Assessment Against Apartment Design Guide (ADG)			
Part	Objective	Discussion	Compliance
3A-1	Design decisions have been based on opportunities and constraints of the site conditions and their relationship to the surrounding context.	A detailed site analysis has been undertaken and addresses the elements specified in Appendix 1 of the ADG.	Yes
3B-1	Building types and layouts respond to the streetscape and site while optimising solar access.	The design of the buildings has optimised solar access through orientation and building separation.	Yes
3B-2	Overshadowing of neighbouring properties is minimised during mid winter.	The entire northern area of the Panthers Precinct has been master planned. All stages have been designed concurrently and respond to an overall outcome for the area. The development will have no impact on solar access to other residential properties.	Yes
3C-1	Transition between private and public domain is achieved without compromising safety and security.	Apartments overlook the public domain to the west, north, south and east. A pedestrian promenade is expressed along the lake side edge with activated retail tenancies. The edge connects with the pedestrian promenade

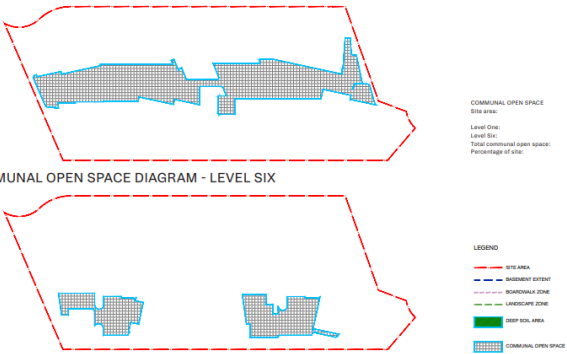
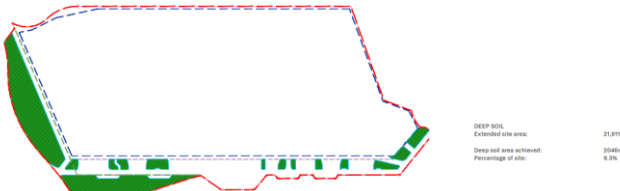
3C-2	Amenity of the public domain is retained and enhanced.	Landscaping is proposed along the pedestrian promenade edge, public domain between Stages 4 and 5, private road front and along facades and roof top edges. A condition of consent is recommended requiring mailboxes within secure lobby areas. Substations are proposed along the private roads. Landscaping is proposed around substations. Access arrangements to residential lobbies are ramped and are capable of achieving compliant grades. Most accessible ramps along the pedestrian promenade are not integrated with the stairs. This results in people with mobility issues or parents with prams to 'search out' an access route which segregates them from other people. A condition of consent is recommended for ramps to be integrated with stairs.	Yes
3D-1	An adequate area of communal open space is provided to enhance residential amenity and to provide opportunities for landscaping.	The ADG suggests a design criteria of communal open space equal to 25% of the site. The proposed development provides a total of 5,221sqm (29.5%) of communal open space across roof tops and at podium level.	Yes
